Meeting: 5/15/2024
Project: Hill and Locust
Applicant: Ben Hudgins Brock Hudgins Architects

Level III Construction of a New Building/Structure

4-D-24-DT

APPLICATION FOR CERTIFICATE OF APPROPRIATENESS

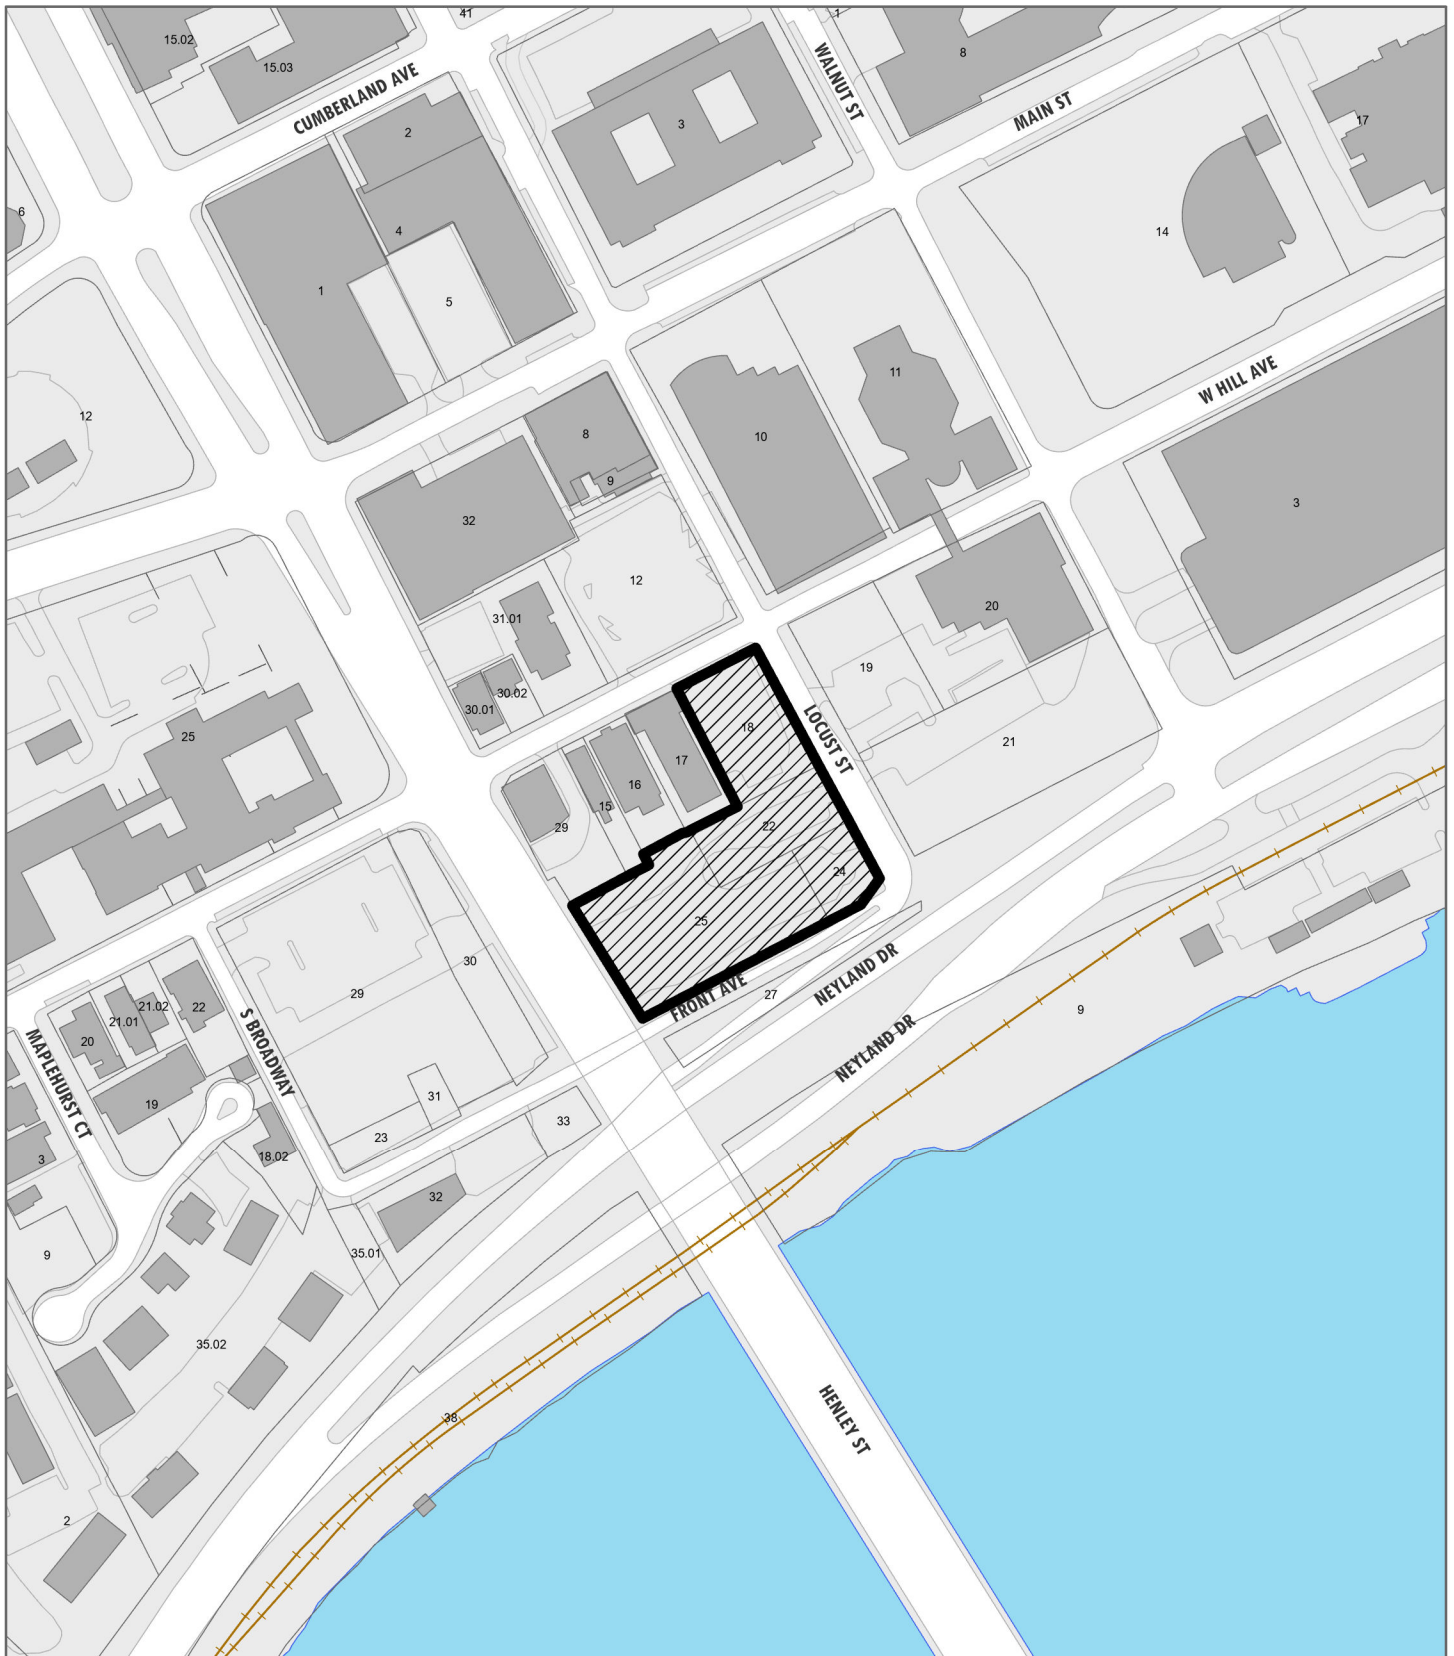
The parking garage design has been revised to include five-story tall diagonal supports. The new diagonal supports contribute to the visual prominence of the parking garage. The ground level of the parking garage is supported by cast-in-place concrete columns which are open to the exterior.

EXTERIOR ELEVATIONS

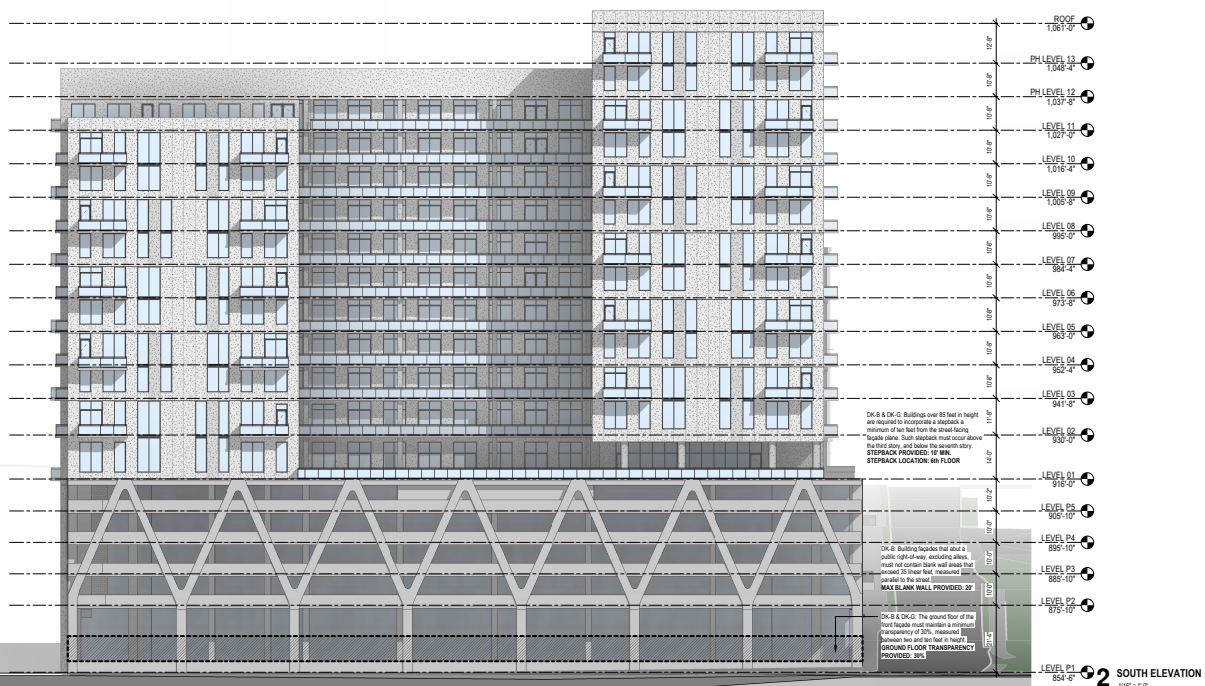
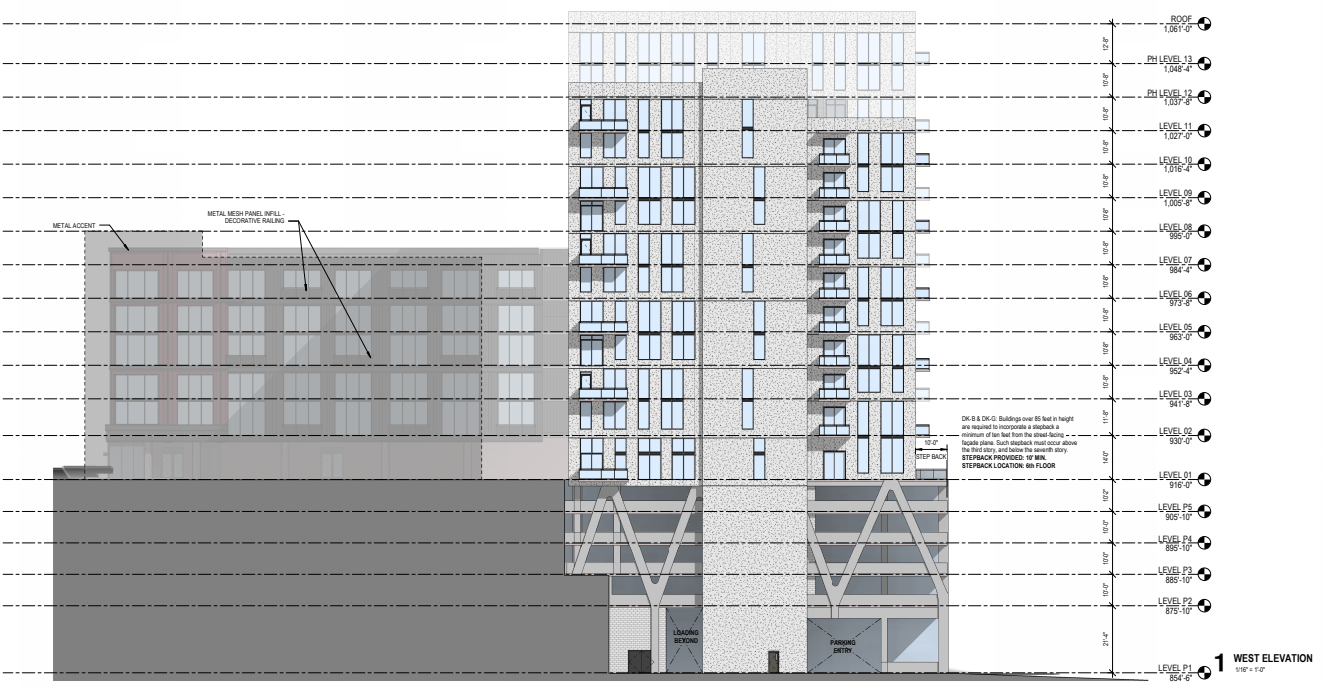
At the May meeting, the Board discussed potential additional pedestrian engagement on the building's south elevation (facing Front Avenue). The DK Design Standards in the zoning code require a minimum transparency of 30%, measured between 2' and 10' in height, on ground floor front facades. To meet transparency standards, the application now proposes an additional open level of parking along Front Avenue. The additional ground-level parking does not further engage the pedestrian experience along Front. The application includes additional streetscape landscaping detail.

5. **MATERIALS:** guidelines recommend the use of building materials that "relate to the scale, durability, color, and texture of the predominate building materials in the area." The surrounding area is characterized by a wide array of exterior materials, including contemporary and historic brick masonry, stucco, and wood siding, along with contemporary office buildings and parking structures. Overall, the proposed hard-coat stucco as a primary exterior material is compatible with the context. The massings on Locust St. and Hill are broken up via different siding, with brick veneer fronting Hill Avenue.
